**M E M O R A N D U M**

**DATE:** June 11, 2018  
**TO:** The Honorable Landmarks Commission  
**FROM:** Planning Staff  
**SUBJECT:** 401 Ocean Avenue, 18ENT-0142

Consideration of Certificate of Appropriateness 18ENT-0142 for design approval of a 5-unit residential condominium development including a new four-story residential building and the retention, rehabilitation, and restoration of the existing residence known as the Henry Weyse/Charles Morris House, a designated City Landmark.

Recessed/Stepped Balconies @ Building Corner

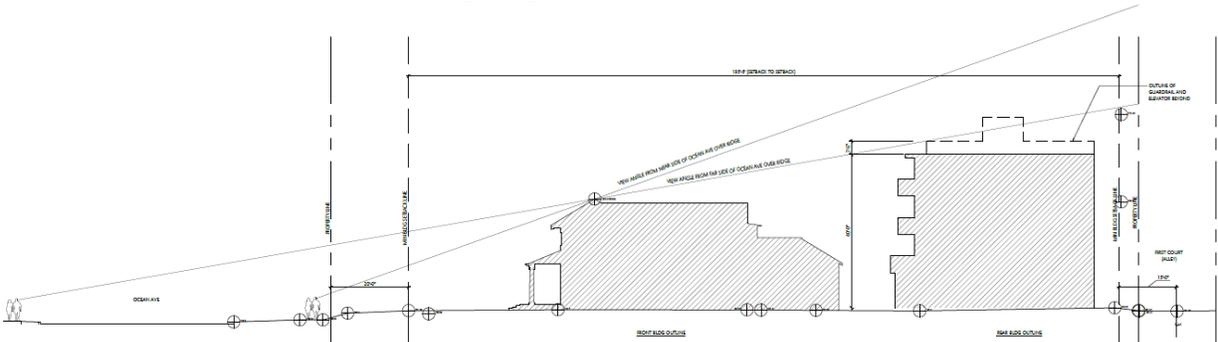
Overall, the new building is setback from and respectful of the historic residence. The building would be setback 20 feet from the street side property line and at least 18 feet behind the Landmark building on all levels. Particularly, the primary balconies on each floor facing Georgina Avenue are angled and setback at the building corner closest to the rear of the historic resource. The building steps back from the Landmark from the ground level to the upper floors, reducing the massing in relation to the Landmark. Further, the inset balcony corners reduce the perceived scale and massing of the new building and soften its appearance in relation to the historic residence. The use of clear-glazed guardrails for the stepped balconies dematerialize the perception of mass through design and materials. Additionally, the ground-level patio includes low semi-permeable fencing that softens the building's ground floor with the common courtyard and is similar in material with the existing side yard trellis.
